GLIDING FEDERATION OF AUSTRALIA.

AIRWORTHINESS DIRECTIVE GLIDERS:

REF. No. GFA/AD 203 SCHLEICHER 10

GLIDER TYPE AFFECTED: Schleicher ASW 19 and ASW 20 All Serial numbers.

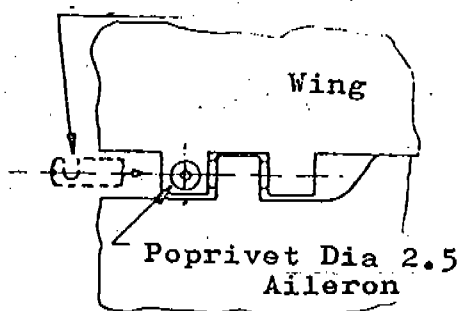
L.B.A. Airworthiness Directive 81-74/2 Schleicher has been received advising that there is a possibility in some aircraft that the aileron hinge shaft may not be correctly secured.

Unless already accomplished, check all the aileron hinges before further flight after receipt of this directive to ensure that the pop rivet securing the aileron hinge shaft is in place. (See illustration).

Ground notch

The rivet head should be able to be felt under the adhesive gap sealing tape but if necessary remove the tape to facilitate checking.
